## Addendum #2

Date: September 14, 2018  
Project: DEARNG Contract No. 2018-07  
BBTS Infrastructure Utilities Project

DELAWARE ARMY NATIONAL GUARD  
 PROJECT # FMO-27845  
 INFRASTRUCTURE UTILITIES UPGRADES  
 DELAWARE ARMY NATIONAL GUARD  
 BETHANY BEACH TRAINING SITE  
 163 SCANNELL BOULEVARD  
 BETHANY BEACH, DELAWARE 19330

UNDERGROUND  
 CONDUIT DISTRIBUTION  
 SYSTEM

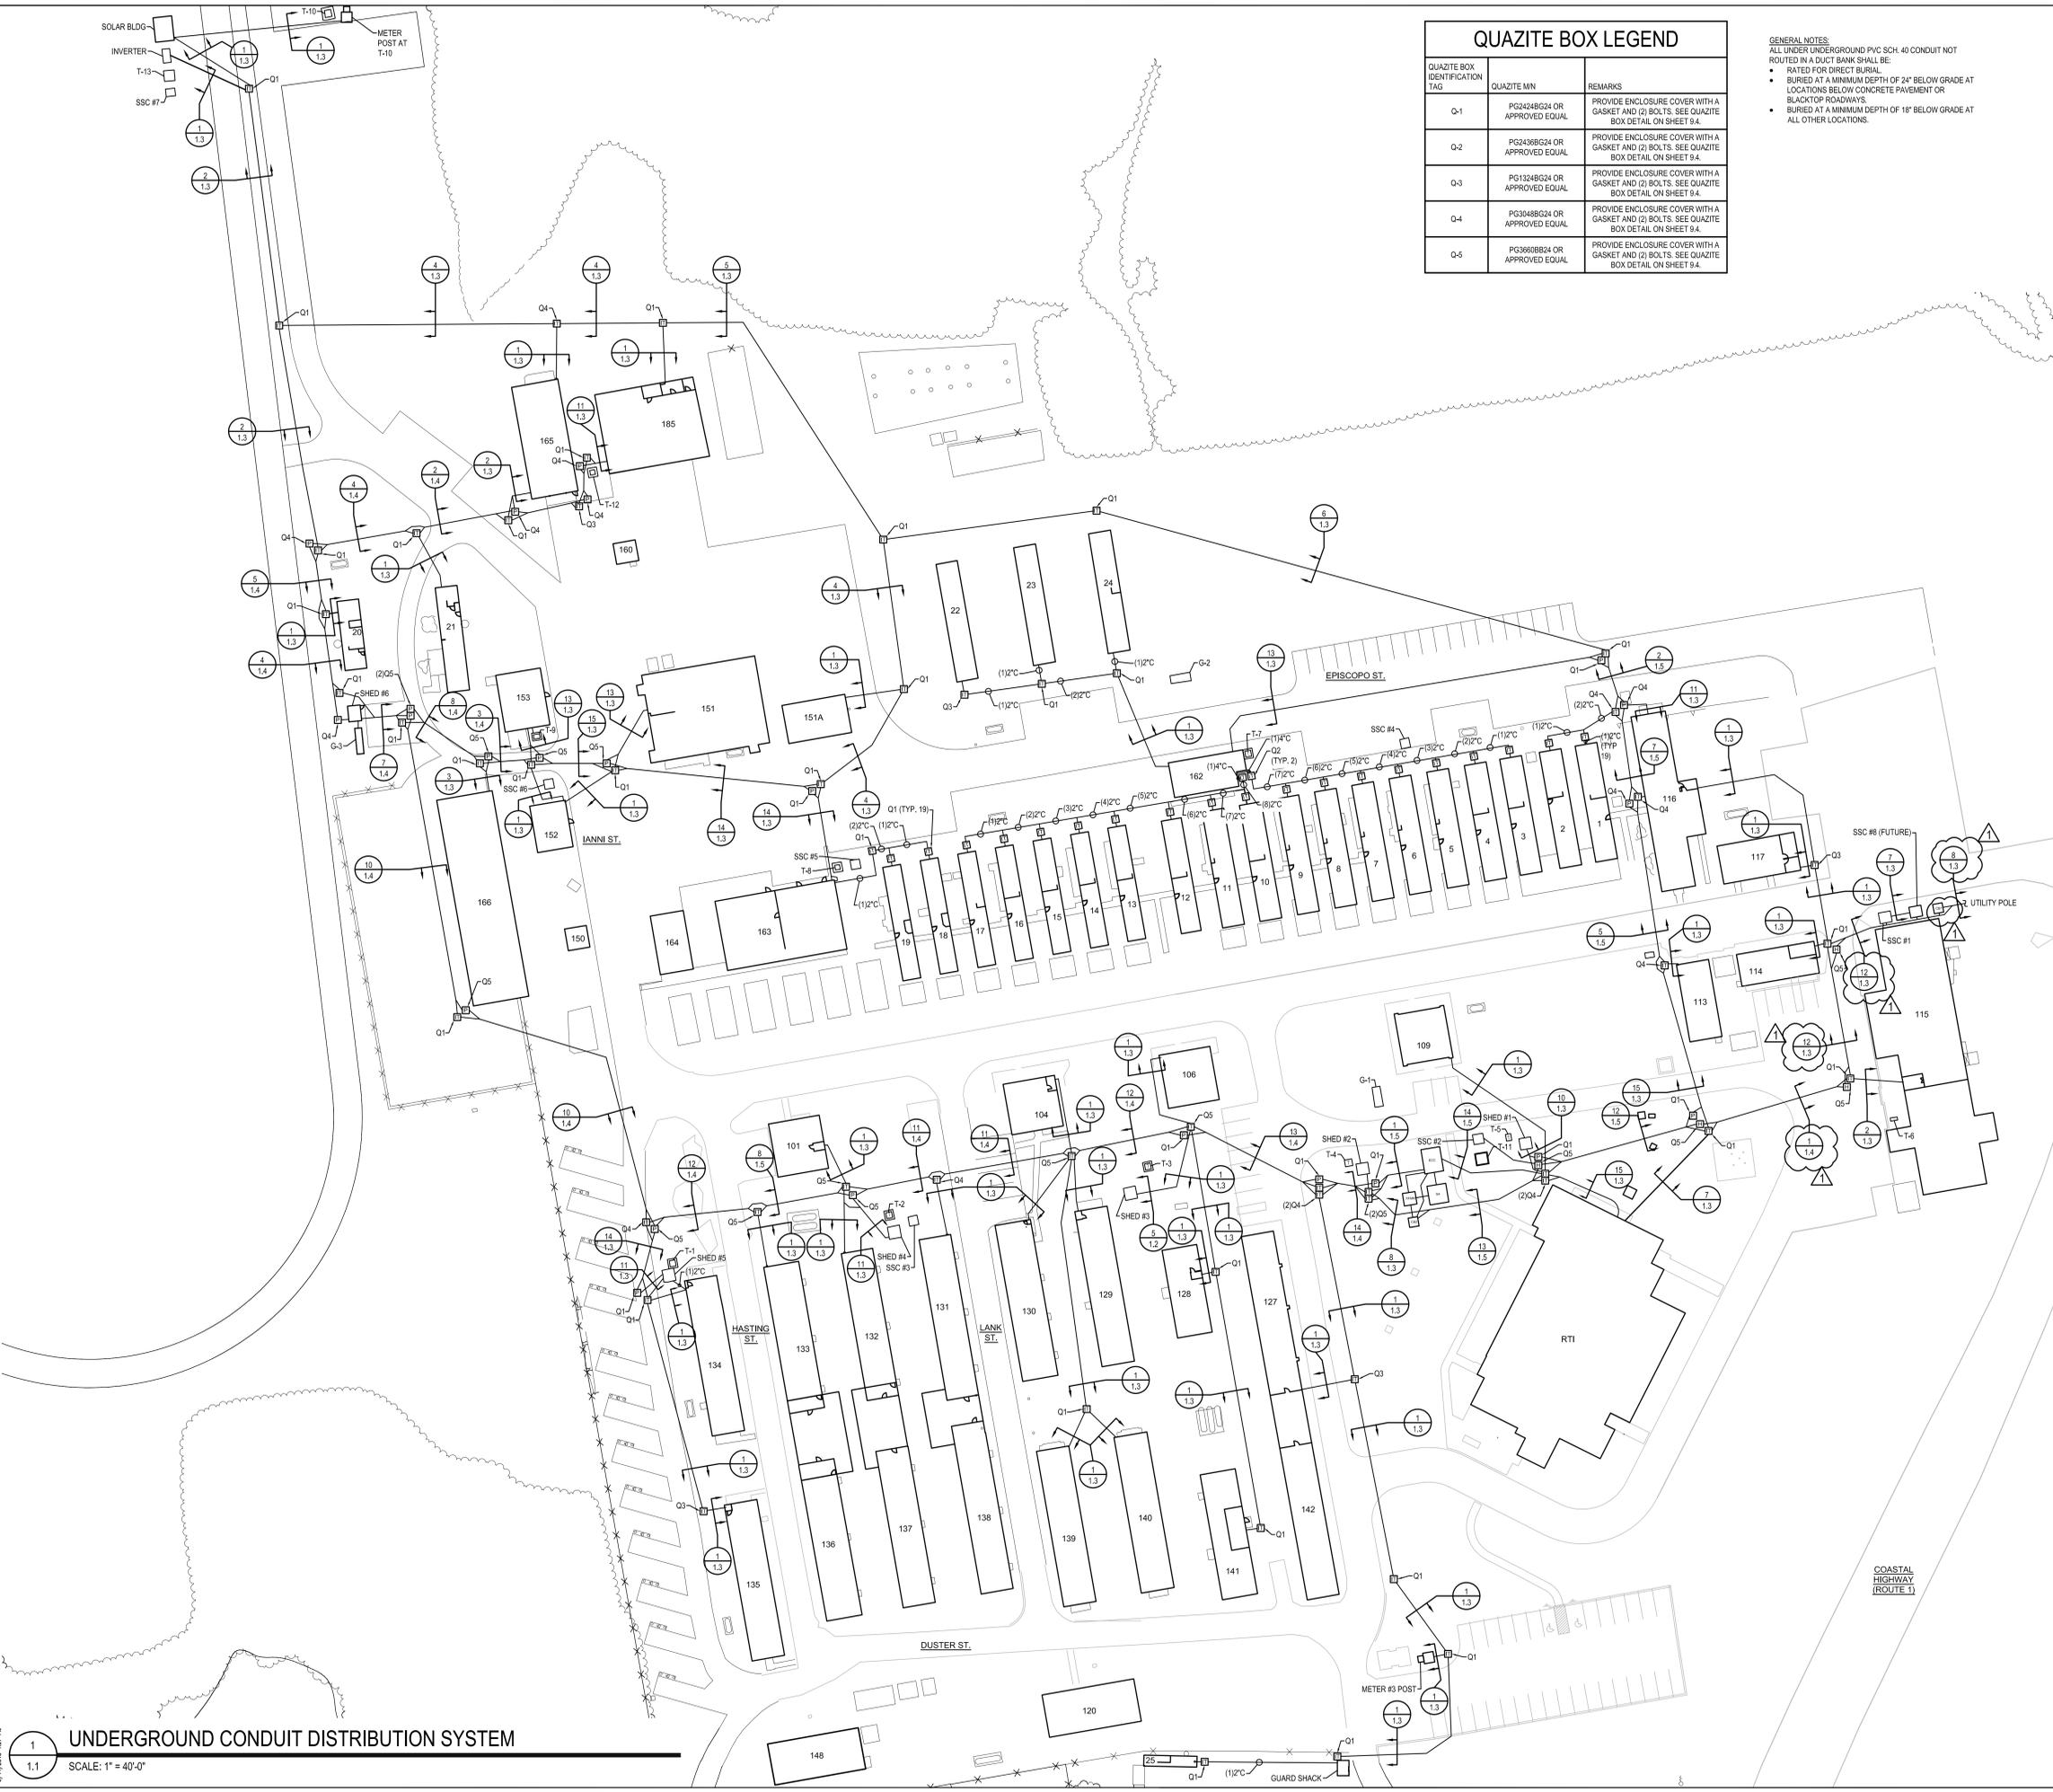
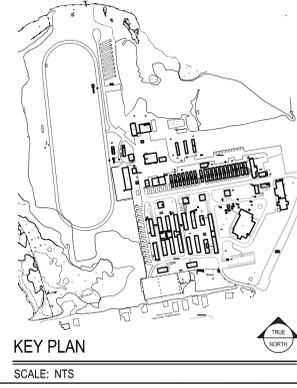
1. *Drawing 1.1 Underground Conduit Distribution System* – Revised the quantities and sizes of conduits. Revised the Duct bank detail callouts to reflect these changes. See revised drawing attached.

15  
1.7 SCALE: 1/16" = 1'-0"

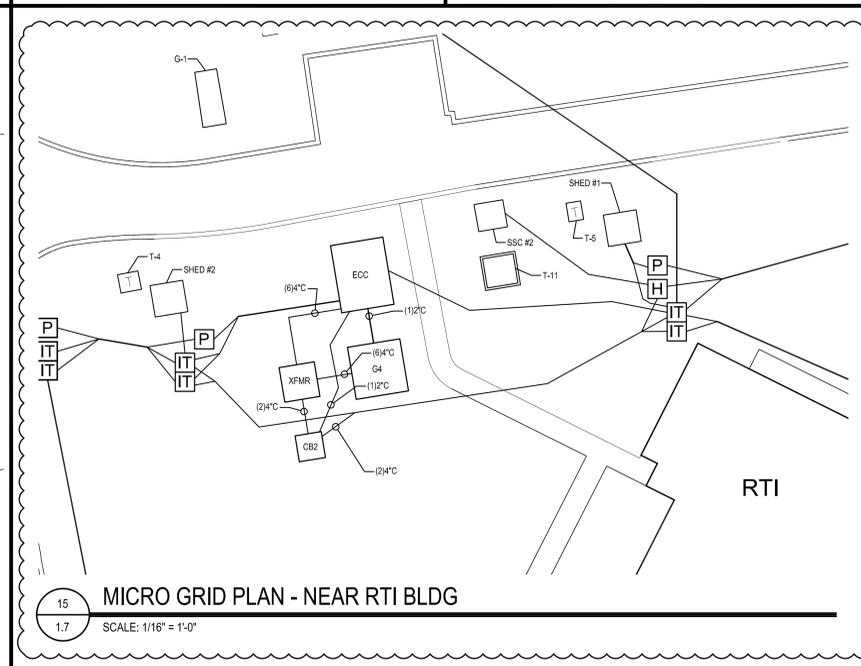
2. *Drawing 1.2 Electrical and IT Quazite Box Locations Plan* – Added callouts for plans 15/1.7 and 16/1.7. See revised drawing attached.
3. *Drawing 1.7 Electrical and IT Quazite Box Enlarged Plans* – Relocated plan 12/9.6 to 15/1.7. Added plan 16/1.7. See revised drawing attached.

4. *Drawing 9.1 Electrical Site Equipment Locations Plan* – Deleted the callout for plan 12/9.6. No drawing or sketch issued to reflect this change.
5. *Drawing 9.6 Alternate #1 Electrical Enlarged Plans Bldg 165-185, Shed #4, 5, 6, & G-3* – Relocated plan 12/9.6 to 15/1.7. Revised the numbering of subsequent plans. See revised drawing attached.
